# **Spring Valley Hydrogeologic Rebuttal Report in Response to Myers (2011a)**

**PRESENTATION TO THE OFFICE OF THE NEVADA STATE ENGINEER**

**SOUTHERN NEVADA  
WATER AUTHORITY**

Groundwater Applications 54003 through 54021 in  
Spring Valley  
and  
Groundwater Applications 53987 through 53992 in  
Cave, Dry Lake, and Delamar Valleys

Figure 1

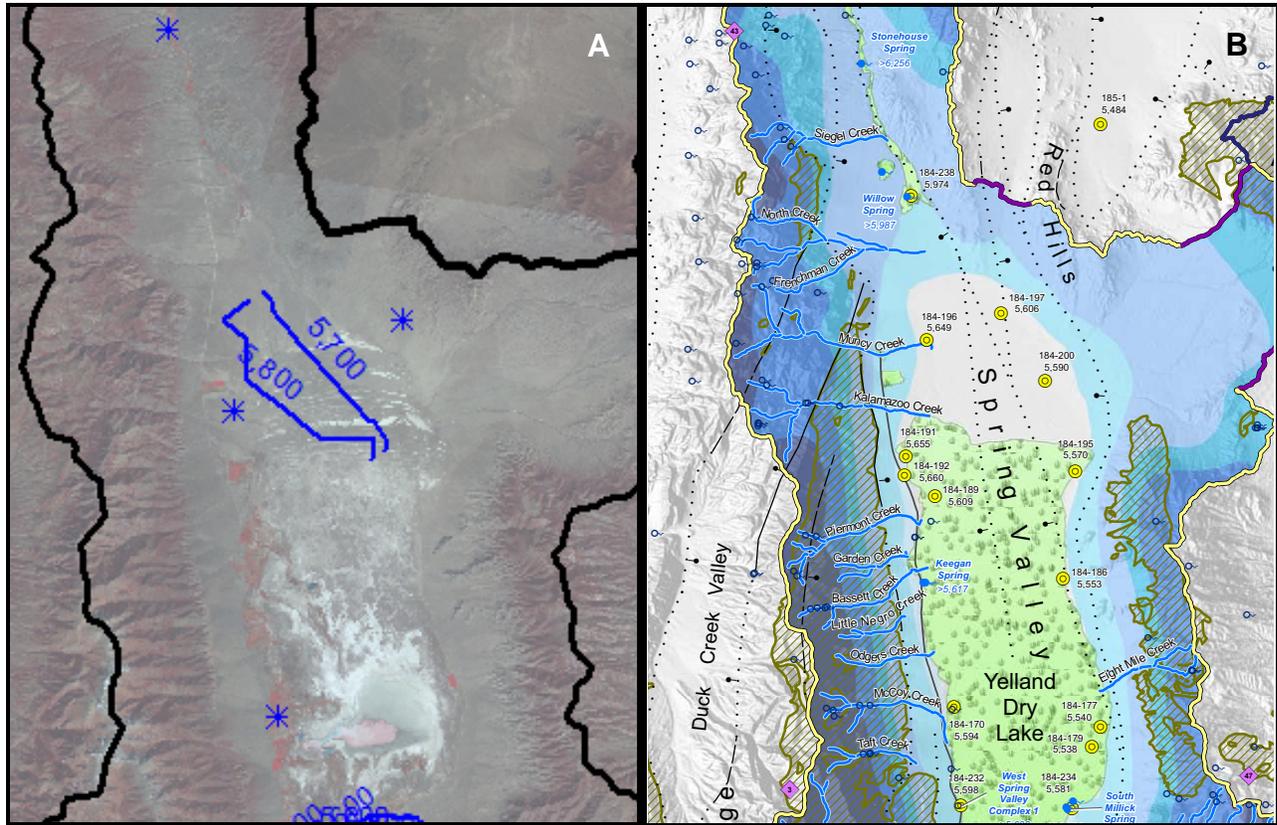
The interpreted hydraulic gradients are also flawed. References to Figures 3 through 5 apparently serve as the basis for Myers (2011a) interpretation of a hydraulic gradient from northern Spring Valley to Tippet Valley. The contours presented on Figure 3 do not support this interpretation, but support a hydraulic gradient in the opposite direction, from north to south. The contours presented on Figure 4 are derived from only two wells, one of which is plotted in the wrong location (see [Figure 1A](#)). This well, 393442114231801 (3934421142318 in Myers, 2011a), is part of the SNWA groundwater monitoring network in Spring Valley and

is actually located approximately four miles to the south (Burns and Drici, 2011, Plate 1, Map ID 184-200). The existence of the second well cannot be verified as it is not documented in Myers (2011a) or in Appendix A of Myers (2011b). The data point appears to be erroneous. Despite the apparent erroneous data, if the first well is plotted in the correct location (see Figure 1B), the hydraulic gradient is not to Tippett Valley as Myers (2011a) concludes, but in fact, to the south and to the groundwater discharge area located along the central axis of the valley (Burns and Drici, 2011, Plate 1). No evidence (data or interpreted contours) is found on Figures 3 through 5 supporting Myers (2011a) suggestion that there is an “...apparent gradient...” and flow path “...between the northern half of Spring and Snake Valley...” Myers (2011a) does not identify the location of this so-called flow path to Snake Valley because no such flow path is supported by his contour maps. This conclusion is baseless. In fact, the geologic and hydrologic features that control groundwater flow in this area do not permit such a flow path. Cambrian-Precambrian siliciclastic rocks extend along the entire western range-front of the northern Snake Range, and the range is underlain by Tertiary-Jurassic intrusive rocks (Rowley et al., 2011, Plate 6). These rocks are confining rocks of very low permeability, and prohibit groundwater flow from Spring Valley to Snake Valley. Further, the hydraulic heads within the groundwater recharge areas within the mountain block and alluvial fans are higher than those on the valley floor. The hydraulic potential created by the difference in hydraulic heads causes groundwater to flow from the recharge areas at higher elevations to the discharge areas on the valley floor. The groundwater

flow suggested by Myers (2011a) would literally be uphill, against the hydraulic gradient, through impermeable rocks.

Figure 11: Variation of conductivity with depth for upper valley fill (Durbin, 2006).

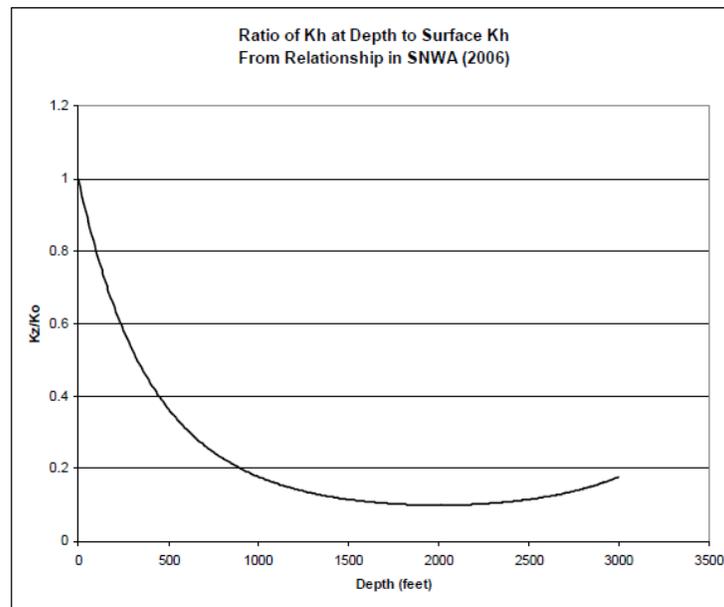
Figure 11 of Myers (2011a) is wrong. Myers (2011a) specifies Durbin (2006) as the source, but Durbin (2006) does not include depths greater than 2,000 ft in the equation as depicted in Myers (2011a; Figure 11). In Durbin (2006),  $K_r$  (Ratio of  $K_h$  at Depth to Surface  $K_h$ ) is constant for depths greater than 2,000 ft. Therefore, the equation is only valid for depths less than or equal to 2,000 ft. Durbin (2006) even stated that the minimum point for this relationship is at a depth of 2,000 ft with  $K_r = 0.1$  at that depth (p. 4-10).

While it is likely that overburden pressure compacts and seals the voids spaces within basin-fill materials, it is beyond comprehension why Myers (2011a) would display a relationship in which the hydraulic conductivity of these materials would decrease with depth, and then suddenly increase at greater depths. The relationship presented in Figure 11 of Myers (2011a) is flawed, and its use in Myers (2011 b and c) and how it affects the results should be disclosed.

**Figure 2**  
**Spring Discharge 2005-2011**

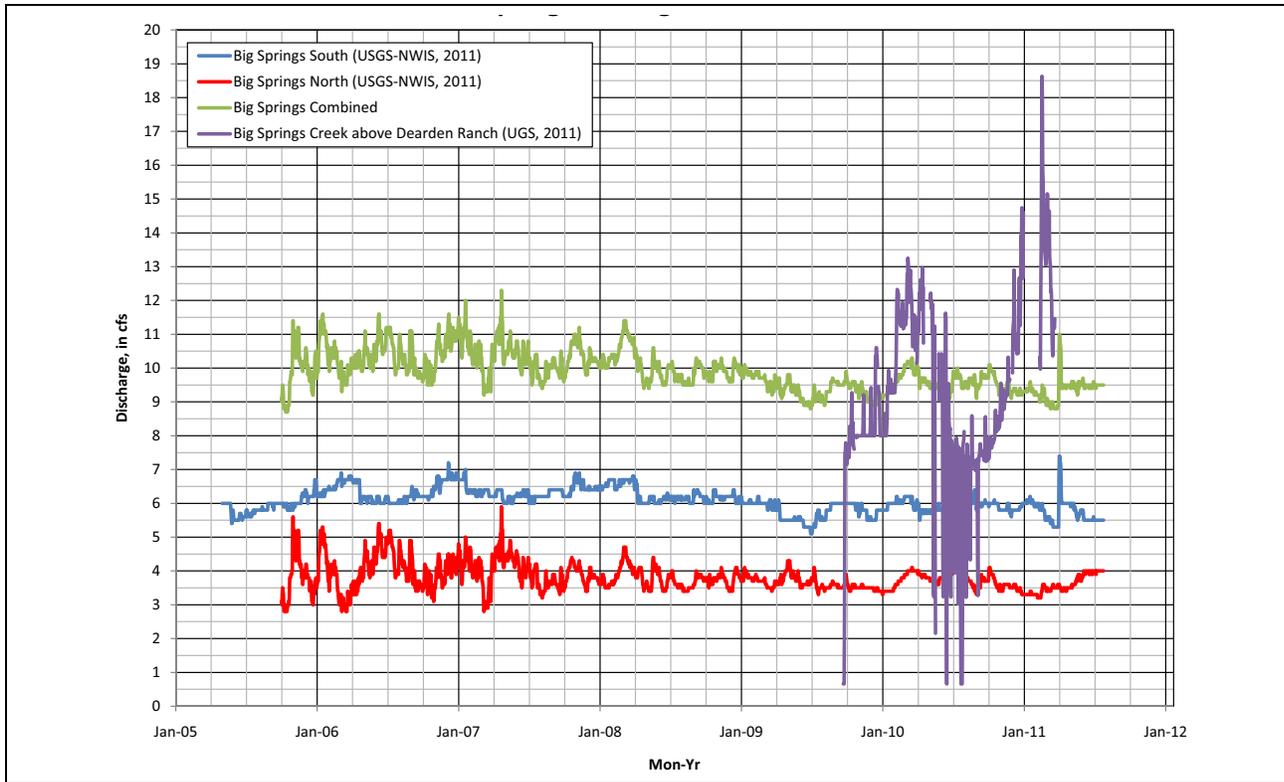
As Myers (2011a, p. 25 and 2011b, p. 32) states, Big Springs is located on the upgradient side (i.e., west) of the fault that controls its discharge. However, the groundwater development is located downgradient to the northeast of Big Springs, not to the west. Without assessing all of the hydrologic factors and gage maintenance activities that can influence the discharge record, it is conjecture on the part of Myers (2011a) to conclude that the downgradient development has caused the spring discharge to decrease by 1 cfs (or about 10 percent). While there appears to be minor drawdown approximately one mile east and downgradient from the pumping center (i.e., a total of approximately 2.5 ft at Needle Point Spring during the period of record for the Big Springs gage; Utah Geological Survey, 2011), the same effects are not discernable in the discharge records for the Big Springs or Big Springs Creek above Dearden Ranch (aka Stateline Springs) gages (Figure 2). Any apparent trends in the discharge records could easily be explained by changing hydrologic conditions (i.e. natural variation) or gage maintenance activities (i.e. changes to the control). Furthermore, the potential effects of pumping in this area would first be observed at the Stateline Springs because it is much closer and downgradient from the pumping (within one mile), and any potential effects to Big Springs upgradient from the pumping (which is over 3 miles from the springs) would likely be attenuated by the north-south oriented faults that control the spring flows and separate the springs from the pumping centers. Before concluding that the pumping is the sole cause of the variation observed in the discharge records, more due diligence analyzing all of the factors potentially affecting the gage record should have been presented and discussed in Myers (2011a).
